**TO BE PUBLISHED IN THE JOURNAL INQUIRER
THURSDAY, SEPTEMBER 10, 2020 AND THURSDAY, SEPTEMBER 17, 2020
SOUTH WINDSOR PLANNING & ZONING COMMISSION**

Re: Mannarino Builders – Special Exception/Subdivision Application
Kilkenney Heights II – Open Space Subdivision
248 Maskel Road & R024 Abbe Road

Grading & Erosion Control Plan

To: Planning and Zoning Commission Members
From: Michele M. Lipe, AICP, Director of Planning
Date: September 17, 2020
Re: Appl. 20-02P, Kilkenney Hts II PZC questions

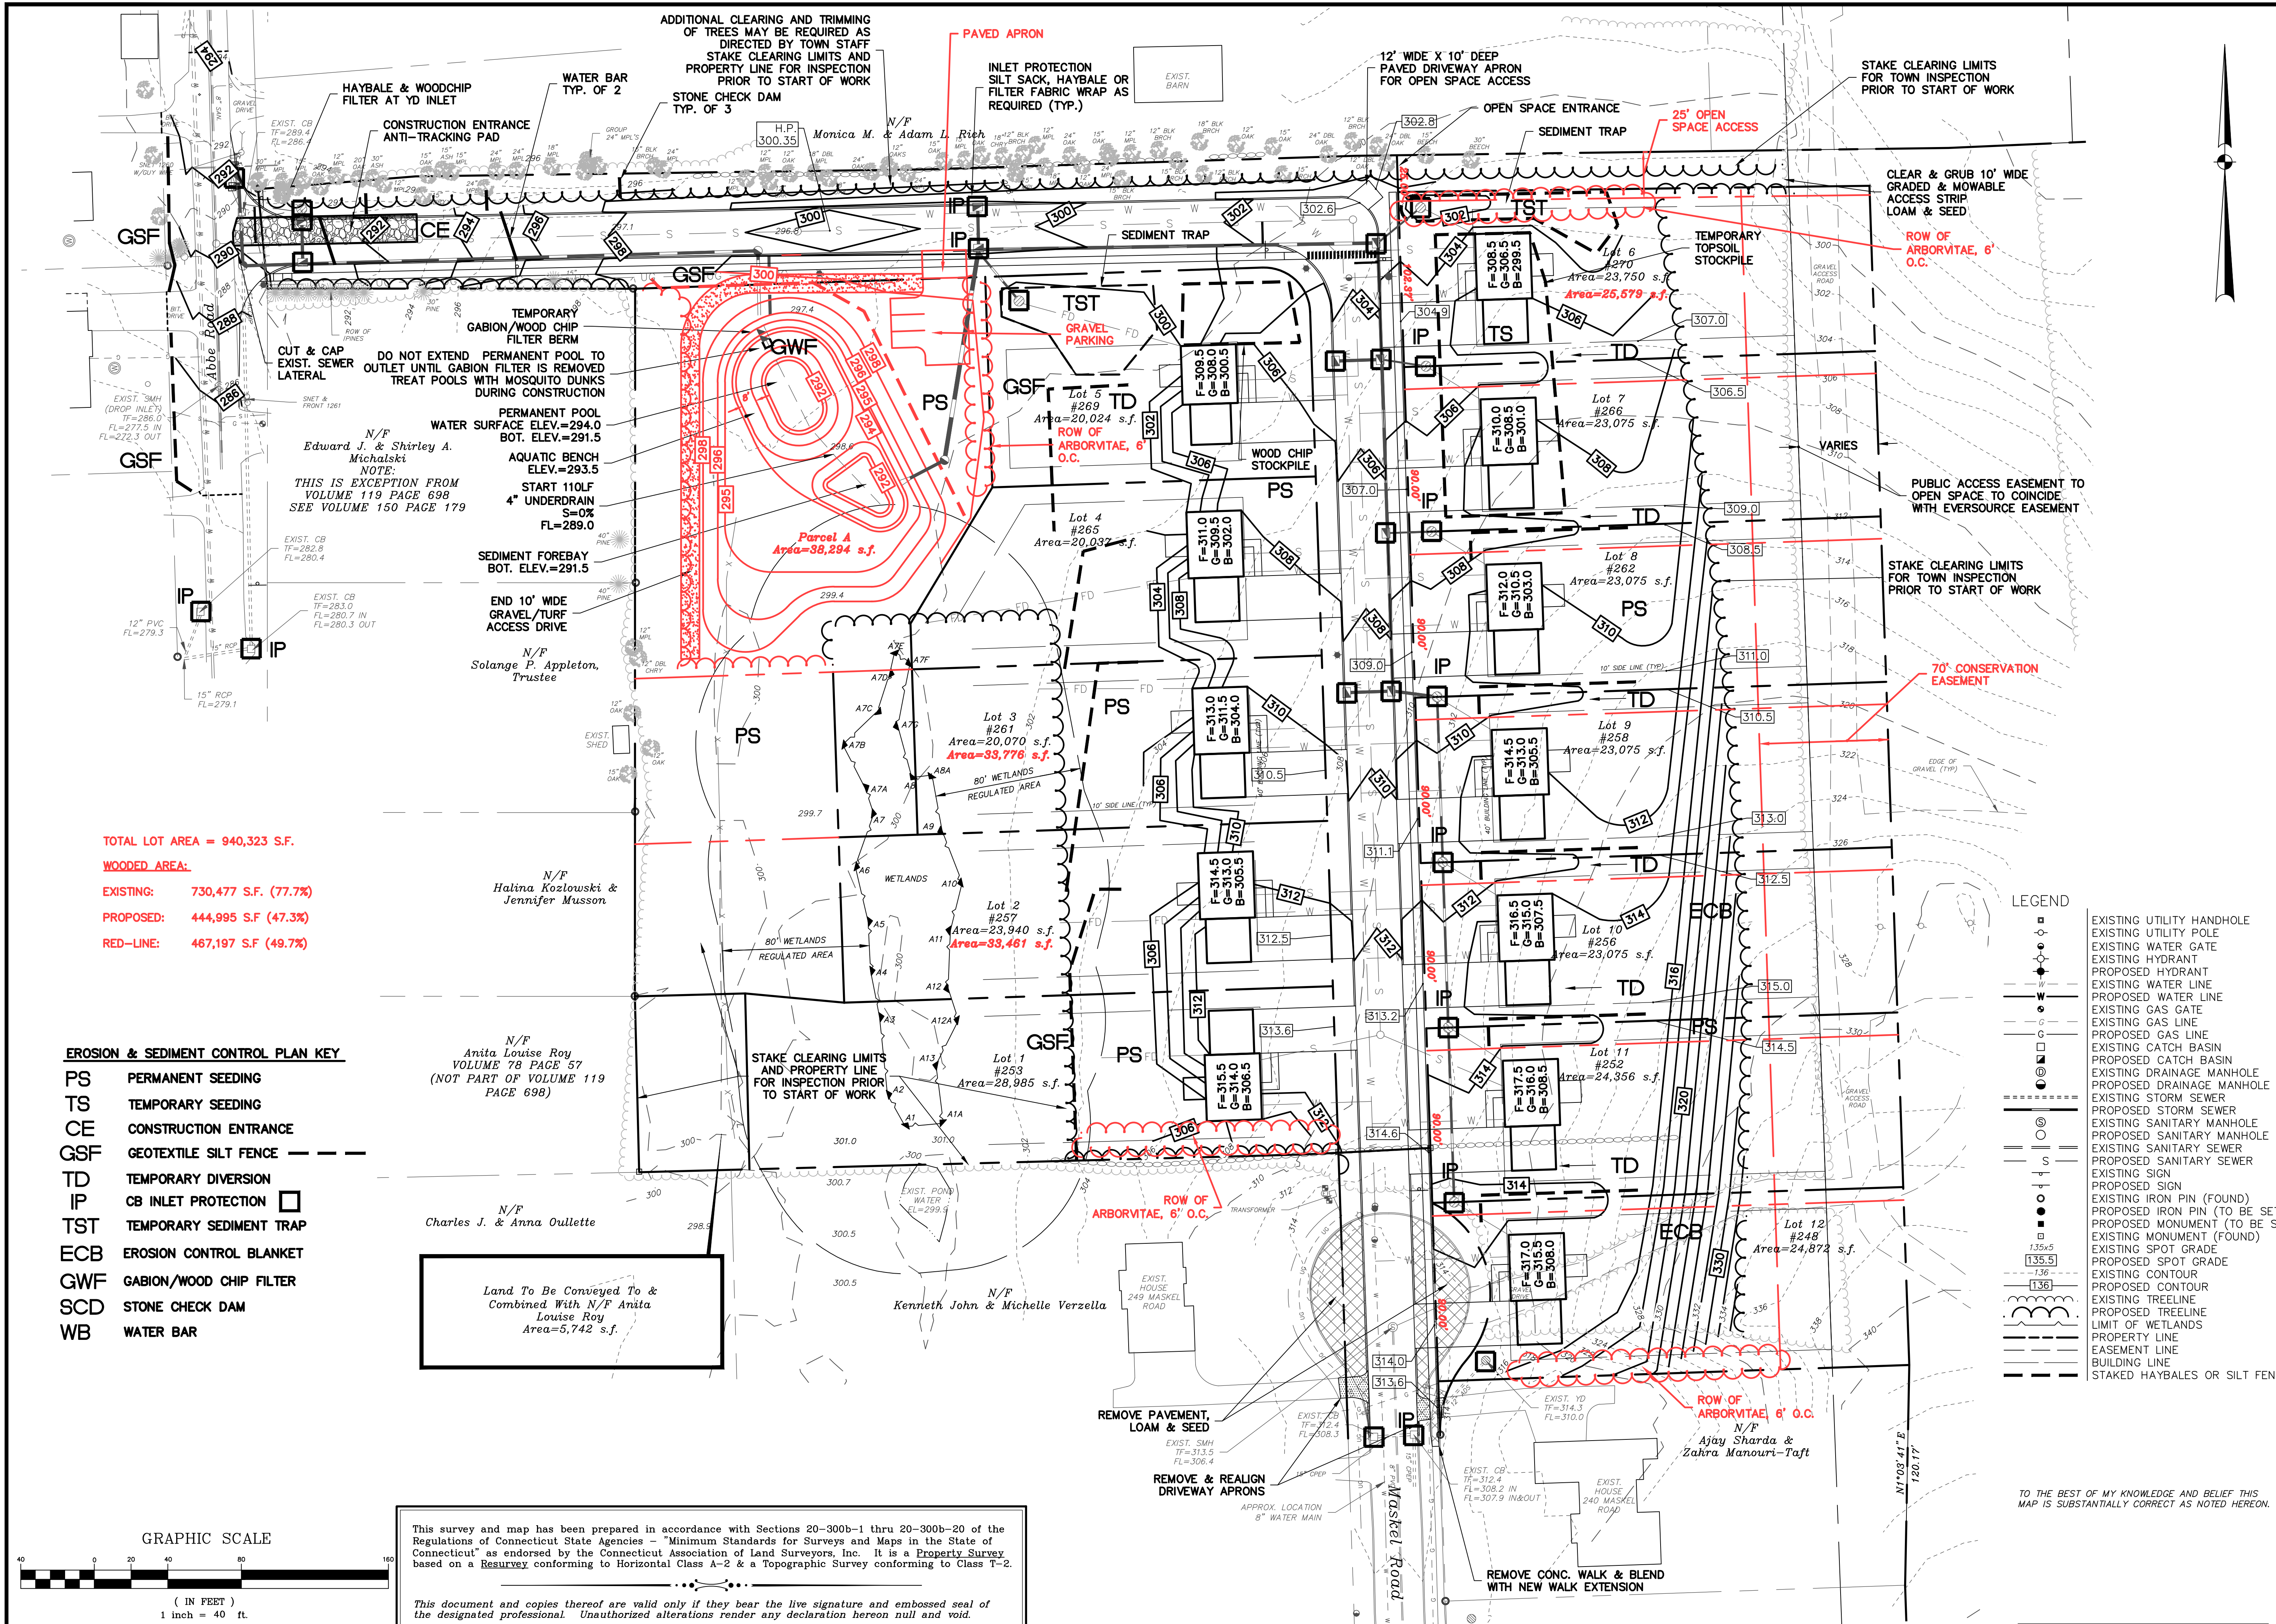
1. Current lot 6 would be eliminated to reduce the project density from 12 new lots to 11 new lots plus the existing lot to comprise a 12-Lot Open Space Subdivision.

2. Three gravel parking spaces would be added in the area of current Lot 6 for open space parking.
3. The size of lots on the east side of Maskel Road (current lots 7-13 would become lots 6-12) would be reduced slightly to increase the width of the open space access from 20' to 25'.

4. The detention basin on the Town Parcel A would be reconfigured to include portion of the previous Lot 6. This reconfiguration would allow us to increase the buffer from the abutters to the west from 10' to 25'. The reconfiguration may also allow us to eliminate some if not all of the grading and tree clearing behind lots 2 & 3 and increase the conservation easement accordingly. The final basin configuration would be subject to staff review and approval.

5. The redline plan also shows arborvitae buffer plantings along the boundaries with existing lots on Maskel Road, Lot 1 and Lot 12 (formerly Lot 13). The previously proposed arborvitae along the open space access will also be adjusted to accommodate the widened access width.

If the Commission prefers this redline alternative, the applicant agrees to incorporate these changes into a final revised plan set subject to staff review of final basin configuration. We look forward to concluding the hearing process. If you have any additional questions, please contact our office at 860-623-0569 or email me at dsteele@jrusso.com.
